ENDL TEXAS

Date: 23 February 2006
 To: T10 Technical Committee
 From: Ralph O. Weber
 Subject: SAS-2 Zoning sans Management

Figure n2 — ~~Figure 45—Zone~~ Zoning expander route table example

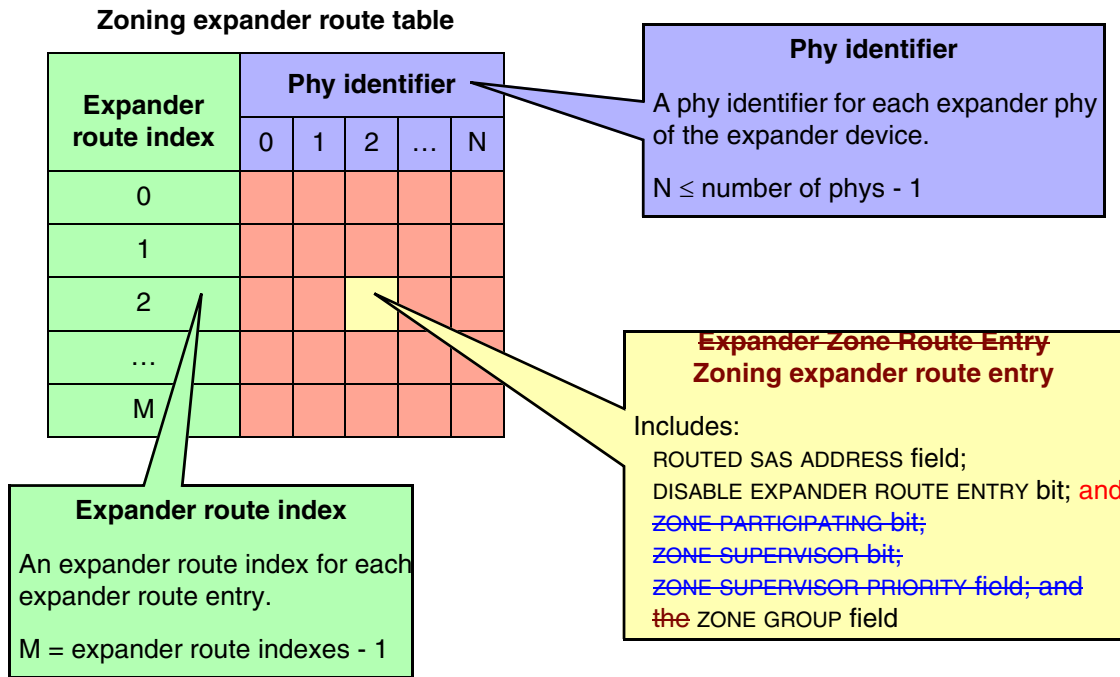
~~Zoning expander devices shall be self-configuring.~~ The zone route table ~~of~~ in a zoning expander device shall contain zone phy information in addition to the expander phy information.

Figure 2 shows a representation of a zoning expander ~~zone~~ route table.
